Lower Wisconsin River Watershed
Comment Form

Comment pertains to:
DFIRM Panel # 550522 0150 A **Comment #** 1 **Other** _____

FOR COMMENT #3

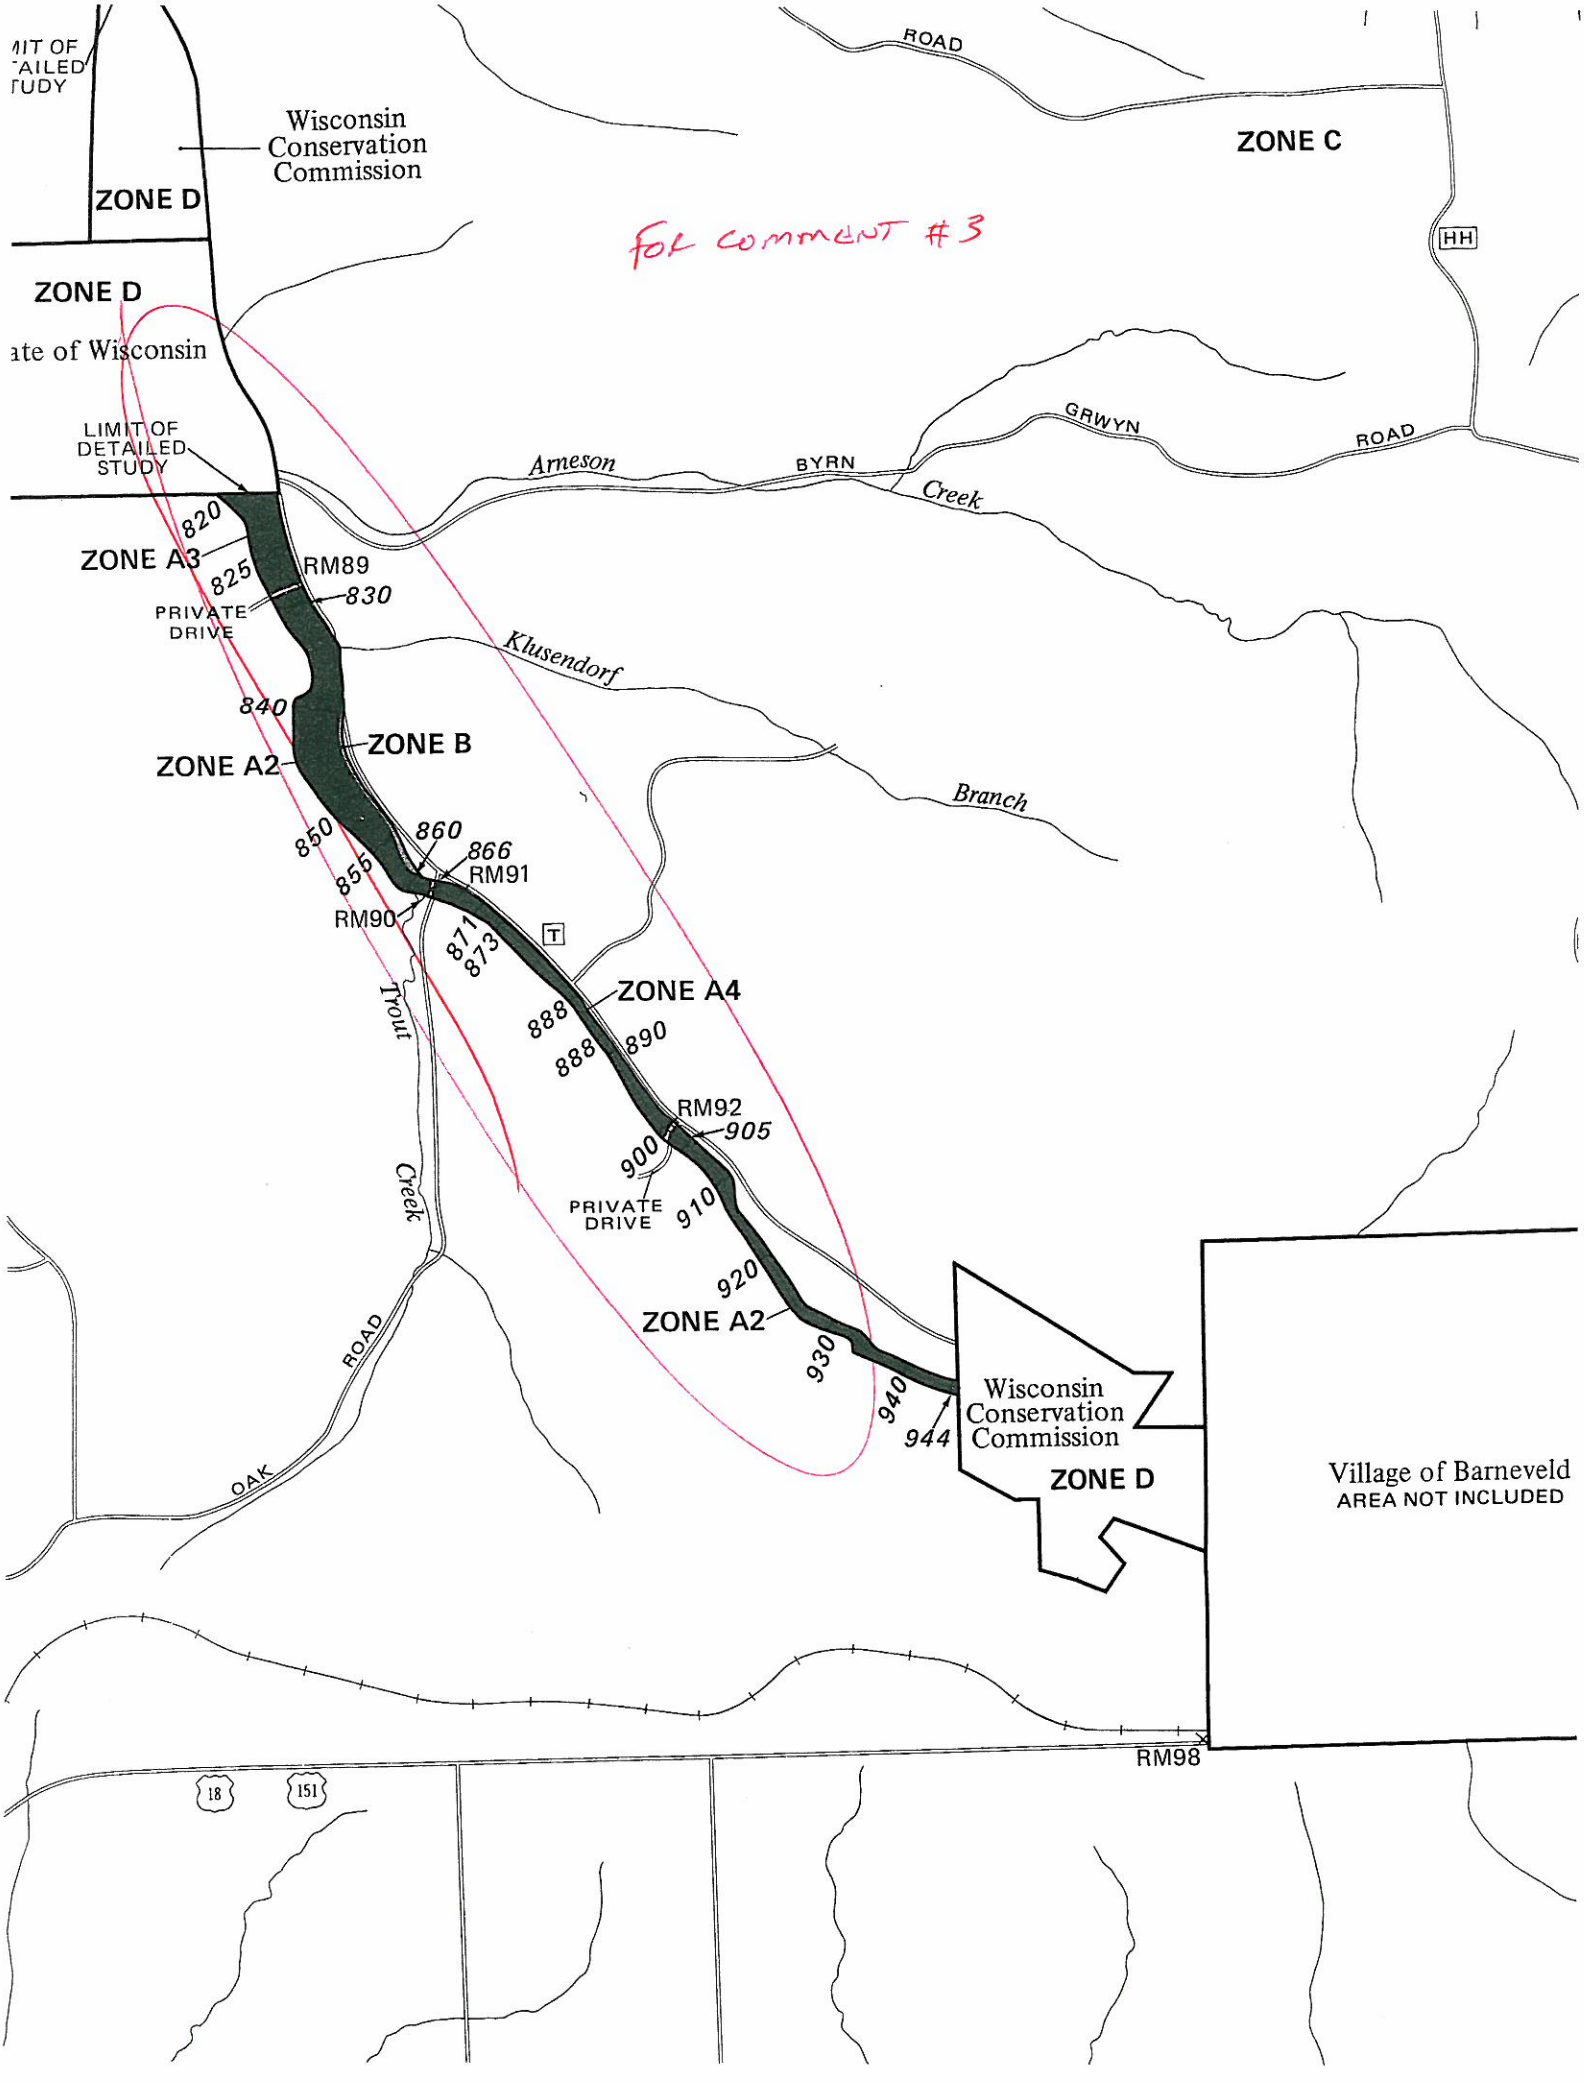
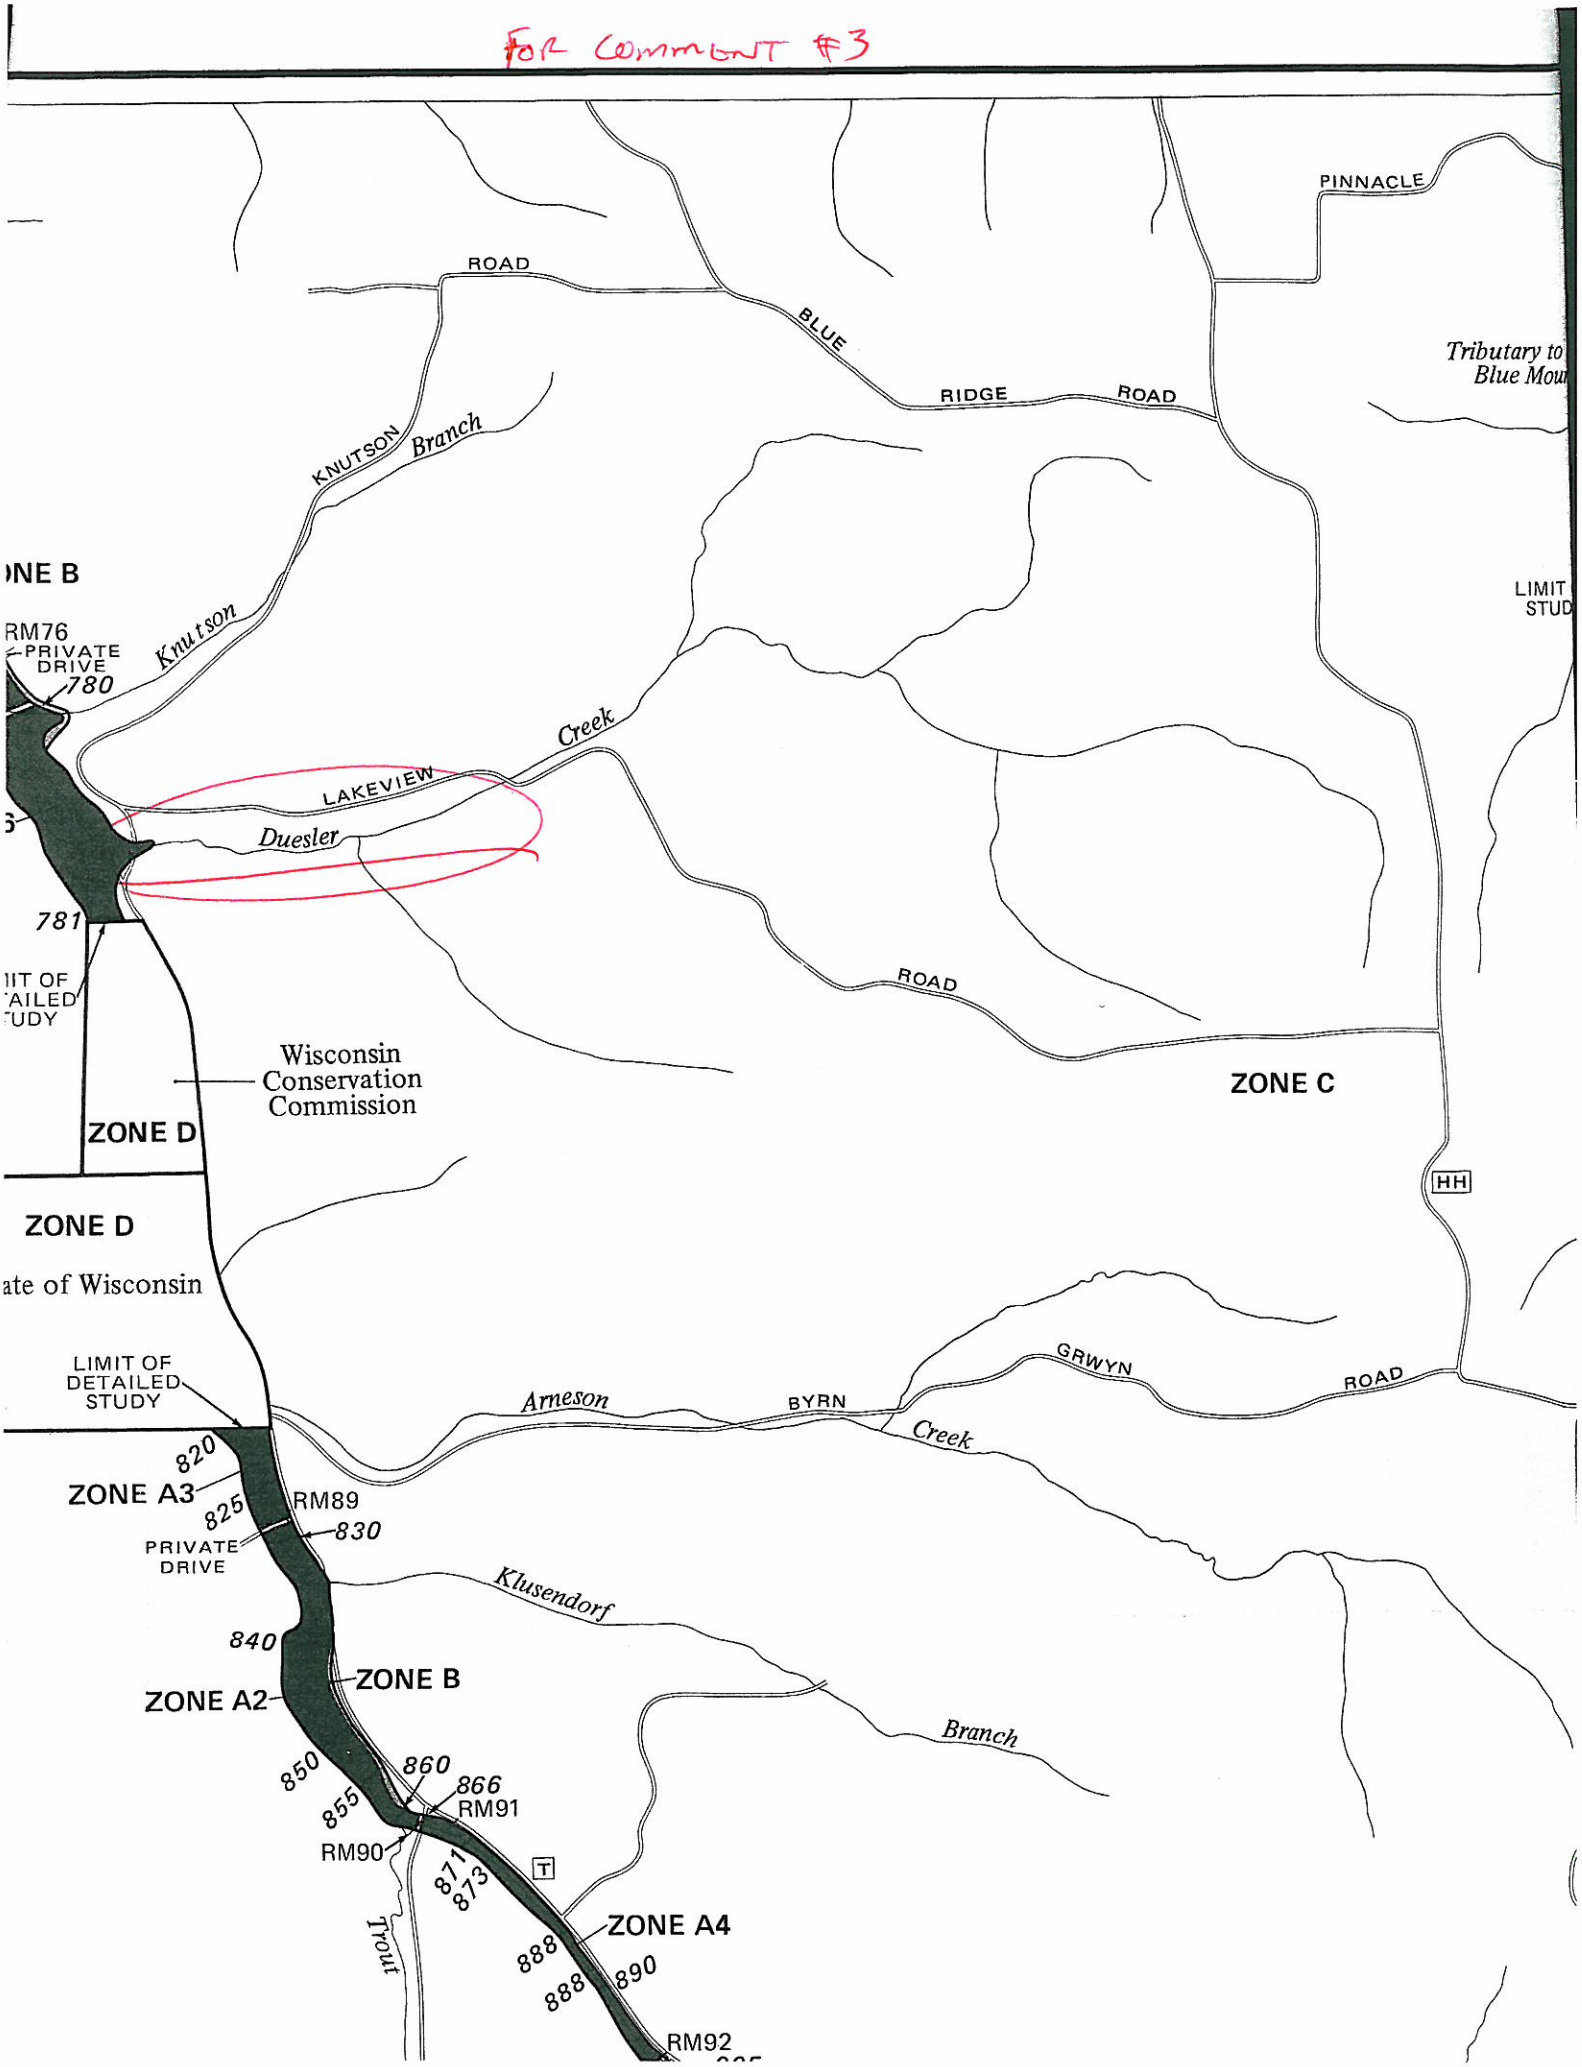
THE COUNTY HAS BREACH DATA FOR A NUMBER OF PL-56 DAMS THAT MAY ASSIST IN ESTABLISHING ZONE AS & DETAILED ZONE AES WHERE CURRENTLY NOT MAPPED. PANELS IMPACTED:

(A) 550522 0075 B : WHITE HOLLOW CREEK ALONG CO RD HH

550522 0125 A : OTTER CREEK ; FLINT CREEK

550522 0150 A : DOESLER CREEK ; TROUT CREEK

FOR COMMENT #5
STATE WILDLIFE AREA BOUNDARY
687
689
690
692
693
Lower Wisconsin River State Wildlife Area
ZONE AE
WISCONSIN
STATE WILDLIFE AREA BOUNDARY
Village of Avoca
(AREA NOT INCLUDED)
C
D
E
ZONE X
RD
HAY
RM7
SOO
LINE
RM8
RAILROAD
133
N
ROAD
RM16
RM 17
Marsh Creek
LEACHE
ZONE X
ZONE X

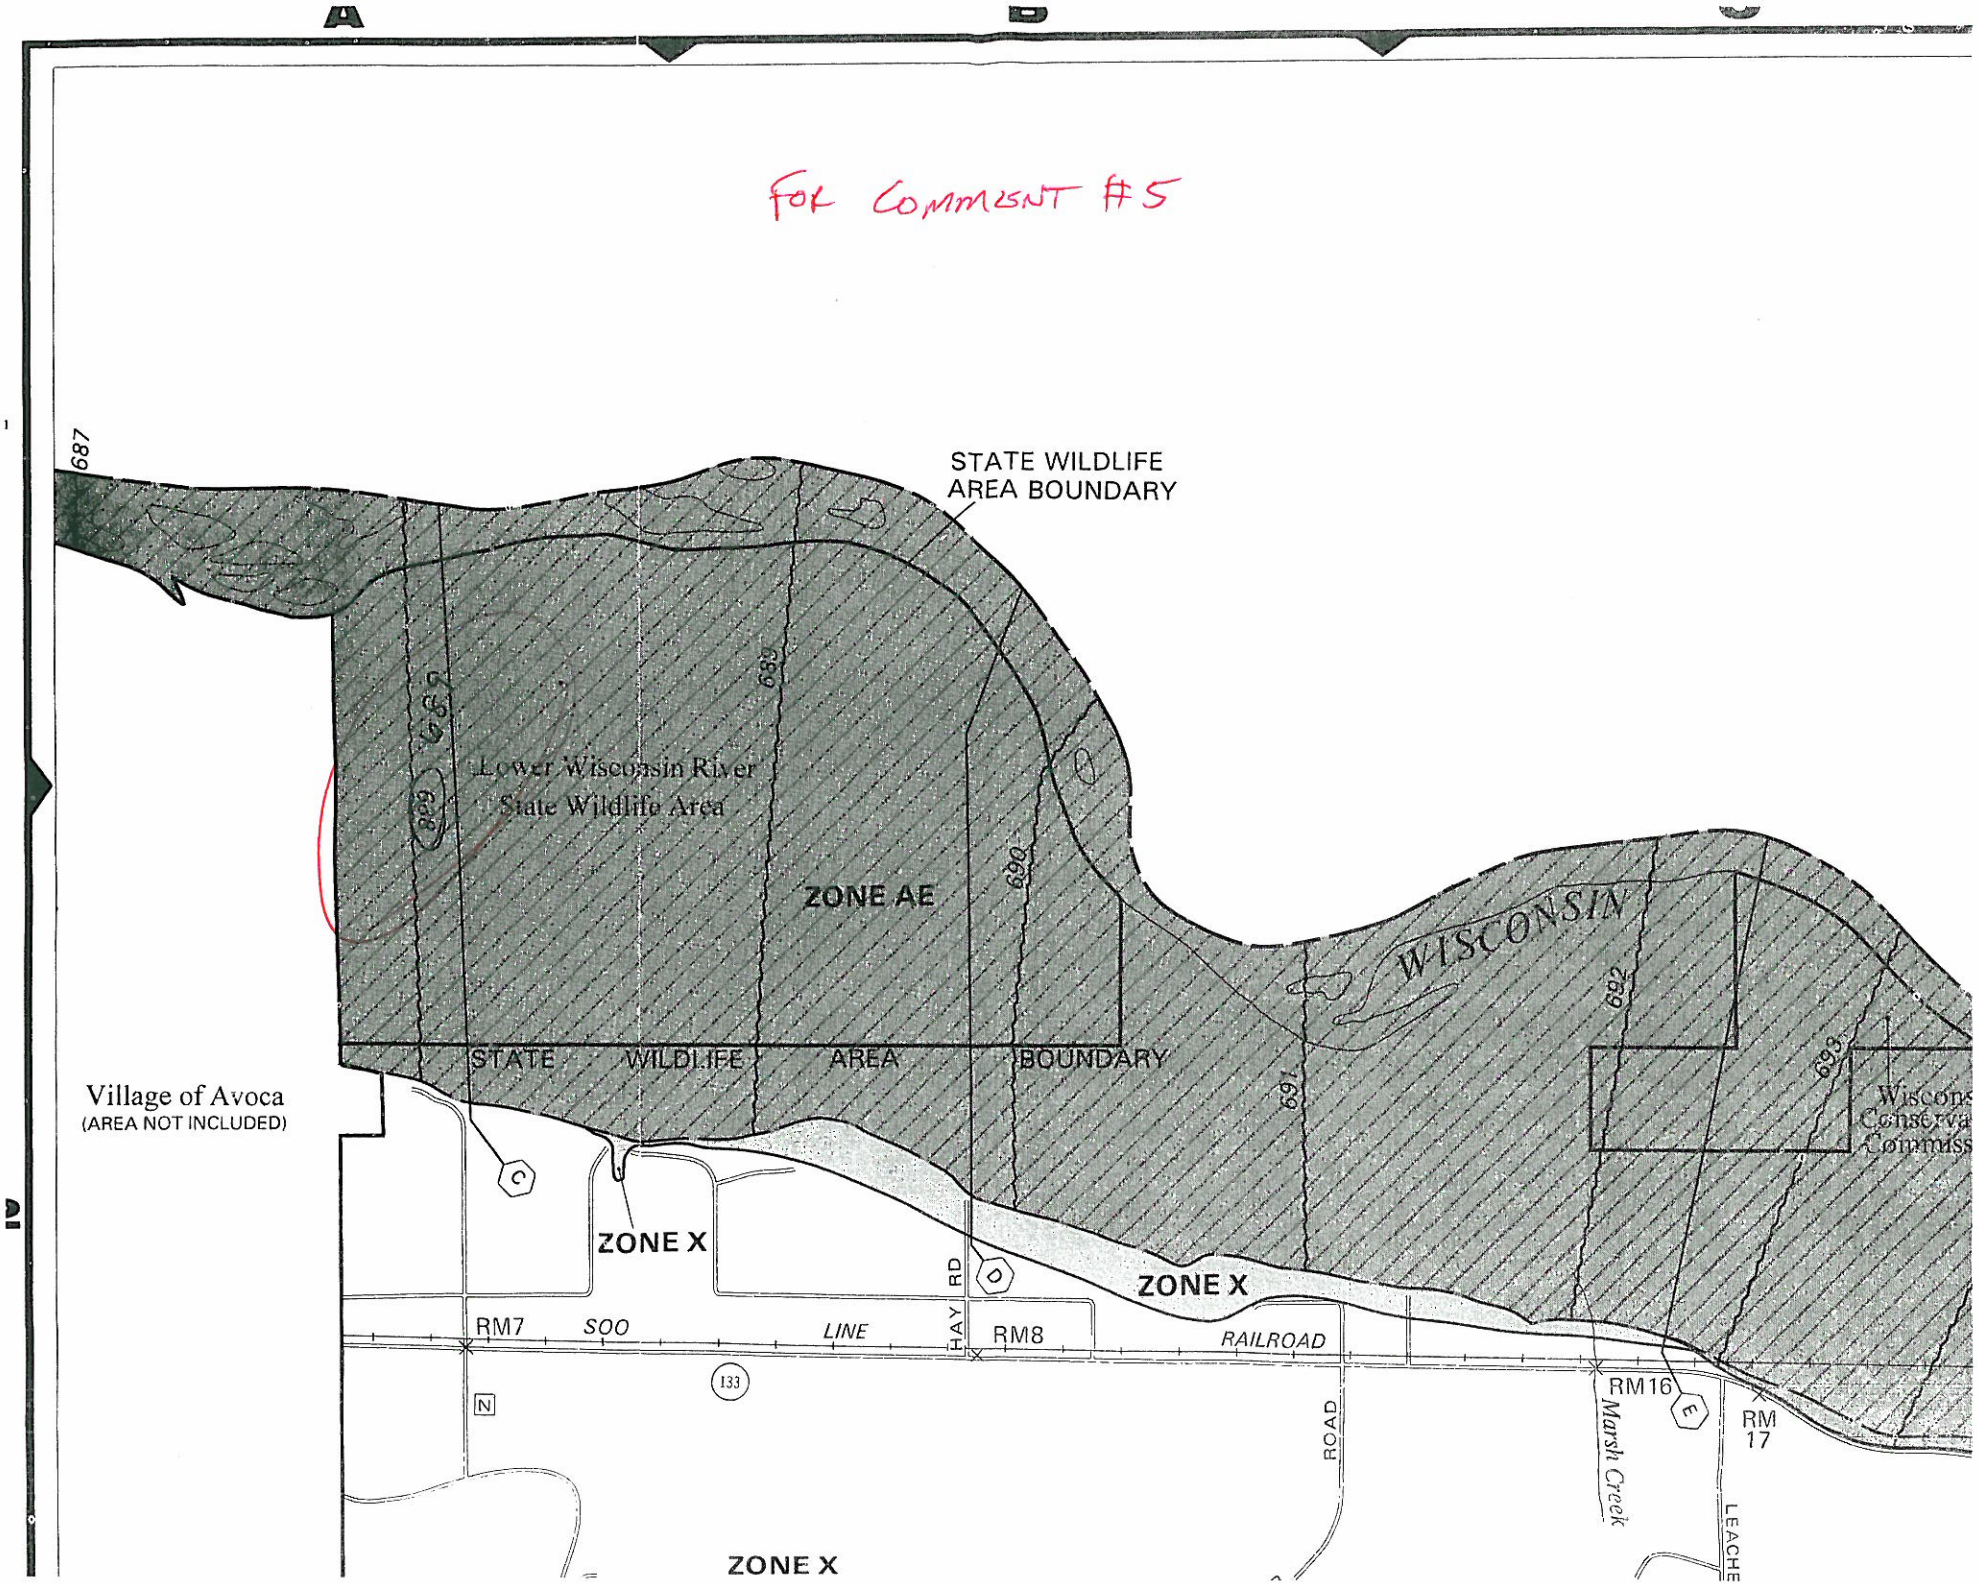
Incorrect RFE (Typo)
